ARM Infrastructure PrimeCell AXI-AHB Bridges (BP137) **Errata Notice**

This document contains all errata known at the date of issue in releases up to and including revision r0p1 of AXIToAHB

Figure 1 Override HTRANS[0] and HBURST to uBLSCnv for write bursts

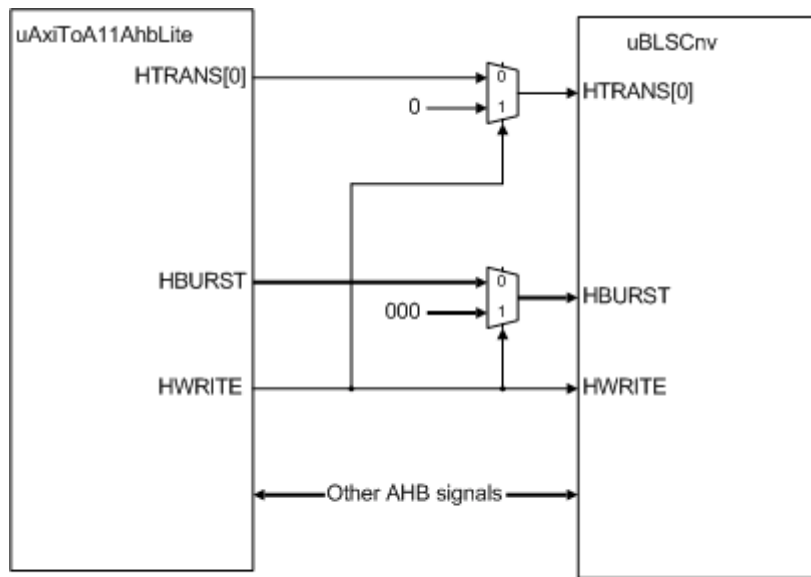
The issue is that the AXI to ARM11 AHB-Lite bridge does not fully support sparse write bursts, i.e. where some bits of WSTRB are de-asserted in order to prevent the writing of certain bytes. The Design Manual correctly refers to a potential protocol violation on the output signal IHUNALIGN of this subcomponent of the AXI to AHB bridges. However, it omits to describe a possible consequent protocol violation on the AHB signals HTRANS, HBURST, and HSIZE at the outputs of the AxiToAhbLiteM or AxiToAhbLiteS variants of the AXI to AHB bridges.

The issue arises when an AXI write transaction begins with an aligned, non-sparse write transfer but one or more subsequent write transfers in the same transaction are sparse. This causes the internal signal IHUNALIGN to transition from low to high at the output of the module AxiToA11AhbLite, as described in the Design Manual. When IHUNALIGN goes high, the byte lane strobe converter (BLScnv) converts each data transfer into series of byte transfers and the outputs HBURST, HTRANS, and HSIZE of BLScnv change. This violates the AHB protocol because the AHB transaction is mid-burst.

This breaks the AHB protocol, because HTRANS must not change from SEQ to NONSEQ, HBURST must not change from INCR8 to INCR, and HSIZE must not change from SIZE32 to SIZE8 until the first burst completes or is cancelled due to an error response.

You should either ensure that the AXI master does not generate write transactions that begin with an aligned, non-sparse write transfer but subsequently include a sparse write transfer, or use the workaround documented in Section 2.2.12 of the Design Manual:

“Every AXI write burst must be converted into a string of single, length = 1, AHB bursts by forcing HBURST to SINGLE, 0b000, or INCR, 0b001, and forcing HTRANS[0] LOW.”

In AxiToAhbLiteM and AxiToAhbLiteS, override the HBURST input to the module uBLSCnv to SINGLE (3'b000) or INCR (3'b001), and override the HTRANS[0] input to the module uBLSCnv to LOW(1'b0) during write bursts. This is shown in Figure 1 below:
